N1094B-02

Information Only Service Note

N1094B DCA-M Sampling Oscilloscope

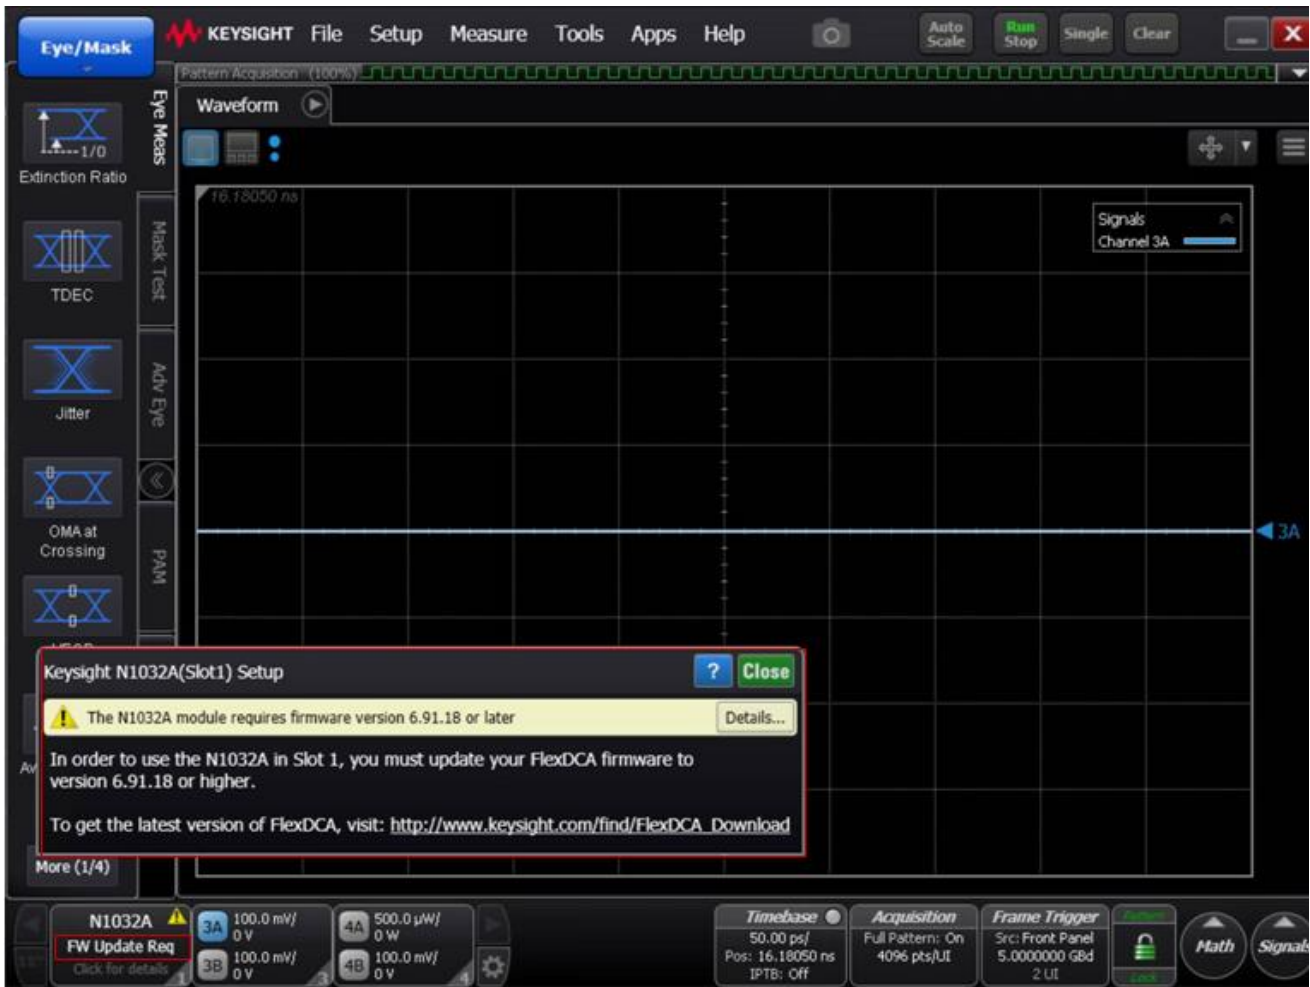
With the instrument connected to FlexDCA, if a message like the one below is displayed, FlexDCA must be updated to the indicated version (or later):

To update FlexDCA software, download from www.keysight.com/find/flexdca_download and install. While only the indicated version is required, updating to the latest version is recommended.
